APPLICATION FOR WITHHOLDING PROPRIETARY
INFORMATION FROM PUBLIC DISCLOSURE
REFERENCE: CAW 79-37

SUBJECT: Docket No. 50-498 and 50-499, South Texas

SUBJECT: South Texas Projects, Units 1 and 2 (Docket Numbers 50-498 and 50-499) Responses to NRC Question 221.2

Question 221.2

Limiting Generic Assemblywise Radial Power Distribution
for South Texas Units 1 & 2

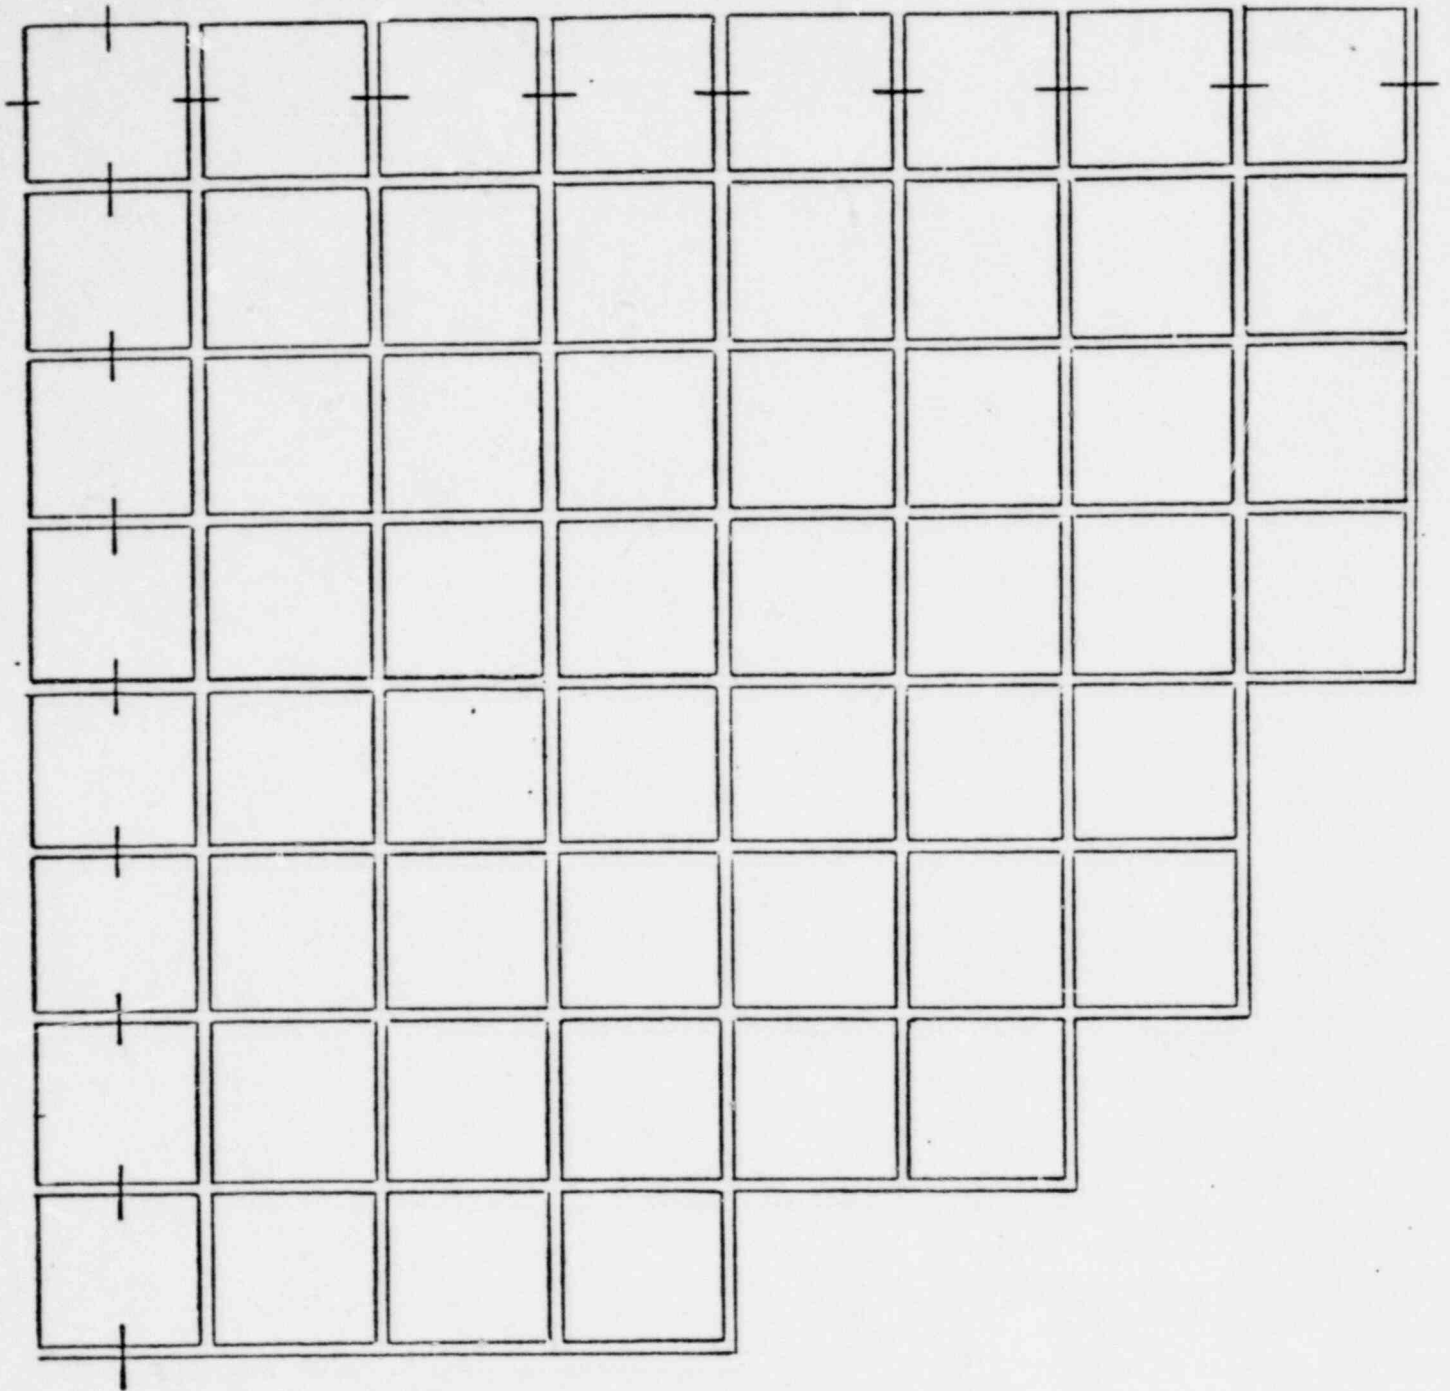
1. Bundle by Bundle Radial Power Distribution
2. Pin by Pin Power Distribution Within the Hot Assembly
